Delaware Department of Transportation
QUESTIONS AND ANSWERS
T201280102.02
STATEWIDE HOPPER RACKS
Thursday, March 14, 2013

P2
S101
TYPICAL ROOF FRAMING PLAN
1/4" = 1'-0"

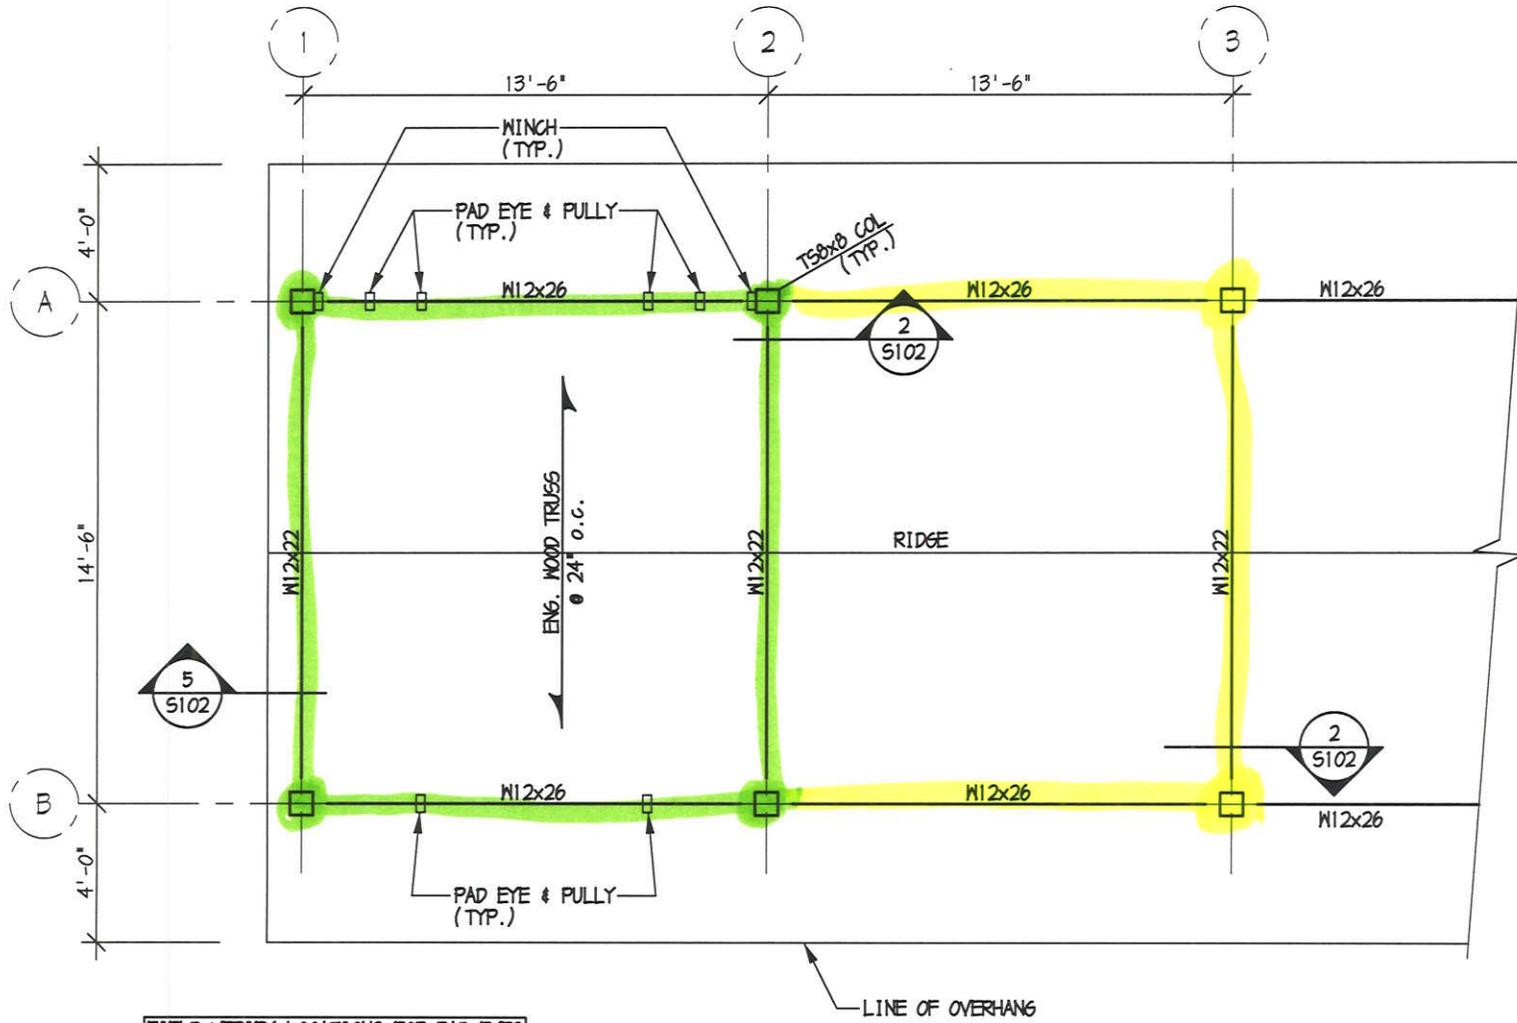
5	Bid Item 763569 Buildings, Descriptions, Location 4, indicates to provide pricing for 1 base bay hopper rack with roof system. Is that 1 bay added to any 8 or 12 bay structures requiring two additional columns and one 13'6" section of roof or is that to be an additional 8 bay structure?	See response to question 4.

Q #	Question	Answer
4	Locations 4 and 5 of Breakout Sheet 1 refer to "Base Hopper Rack Bay" and "C shaped Add on to Base Bay". Please provide definitions for each on these items and what is to be included in each of them.	<p>Location 4 is intended to be the unit price for one square bay, to be used as the price for the first hopper bay in a row at any add-on locations. This includes the footings and steel but no site work (outside the actual construction of the posts) or roof systems (except holes drilled for future roof systems, like Magnolia).</p> <p>Location 5 is for each subsequent bay connected to a location 4 bay at the particular add-on location. Because the "base" unit would already be included (as "location 4"), only three sides would essentially be needed (which is why the term "C" shaped was used in the specifications). Again this includes the footings and steel but no site work (outside the actual construction of the posts) or roof systems (except holes drilled for future roof systems, like Magnolia). Please note, we must have a location 4 bay first before we can add additional location 5 bays. There is however no limit to how many location 5 bays that can be added to any given location 4 bay. This was also described on page 9 of the pre-bid transcript.</p>
